DESCRIPTIVE REPORT

Registry No. H-11331

General Locality Shumigan Islands and Vicinity

Sublocality South East Entrance to Popof Strait

Figure 2. LIDAR Junction Survey H11147¹⁴ and H11331

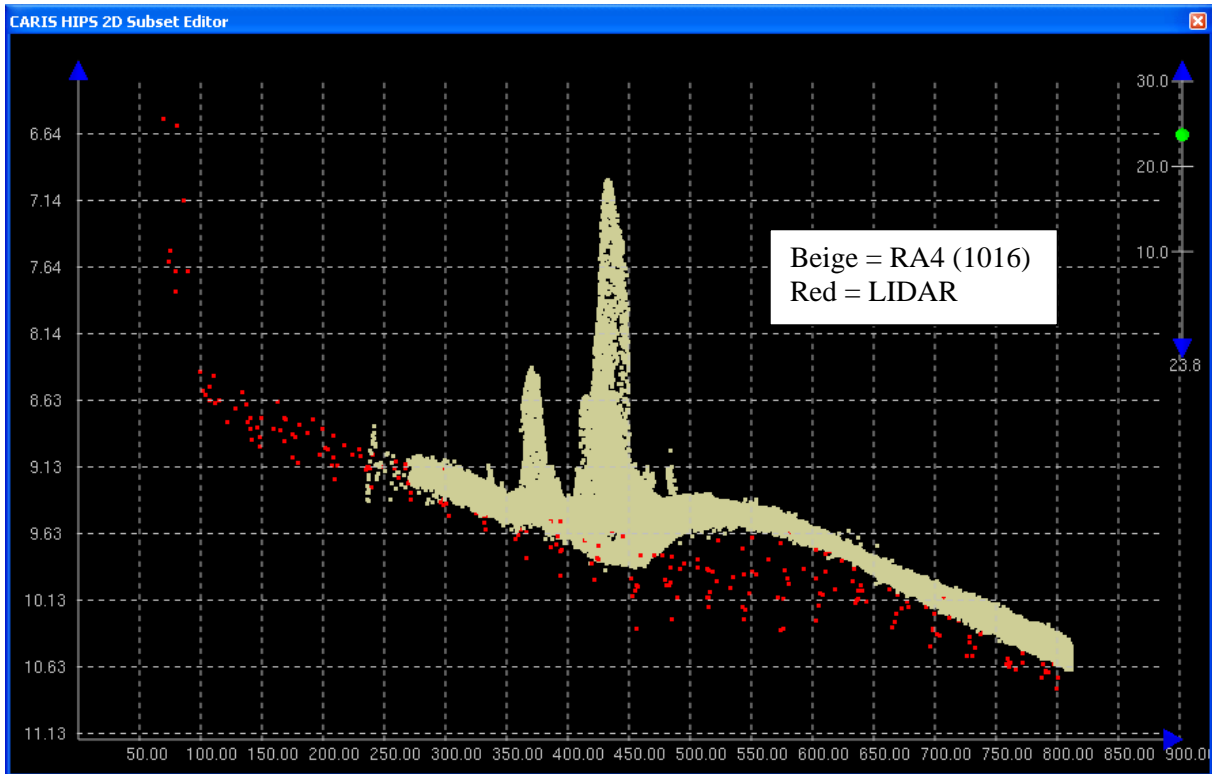
LIDAR survey H11147¹² junctions well with this survey. A cursory comparison indicates no notable differences in most areas, except for the western shore of Simeon Bight. Several features at approximately 9 meters were detected by SWMB but not by LIDAR. Vessel RA4 (1016) day number 2004-207 line 025_2241 shows shoaling up to 7 meters. The LIDAR did not detect these features because coverage in this area was sparse.¹³

¹⁰ The LIDAR junction survey is H11147e.

¹³ Concur with clarification. Selected features and soundings from H11147e were depicted on the H11331 smooth sheet, generally in areas of overlap. In some areas where there was insufficient swmb or VIBES data for contours, dashed contours were created on the H11331 smooth sheet using data from H11147e. Both H11147e and H11331 have been compiled to the Hdrawing.

¹⁴ H11147e.

Figure 4. Error in 'Heave Filter' for vessel RA5 (1006) in Red Cove

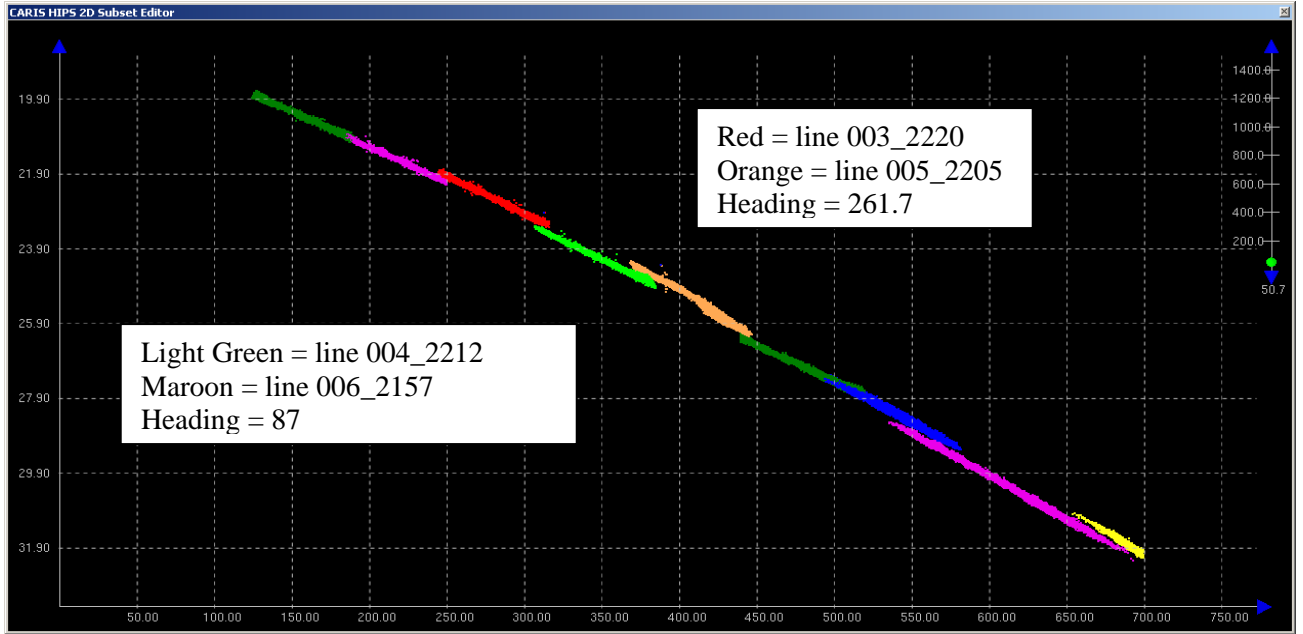
Also during post processing the hydrographer noted a ‘heave filter’ issue on RA5 (1006) in Red Cove in approximately 24 meters of water and in Simeon Bight in approximately 15 meters of water. Every other line, run in¹⁶ opposite direction, appears to have an offset of less than one meter. After the survey was complete it was noted that the heave filter on the Position and Orientation System for Marine Vessels (POMV)¹⁷ was set too low causing the system to take a longer time to ‘settle’ or ‘level out’.¹⁸ See figures below.

¹⁸ In PHB reprocessing, the data was found to be acceptable for charting.
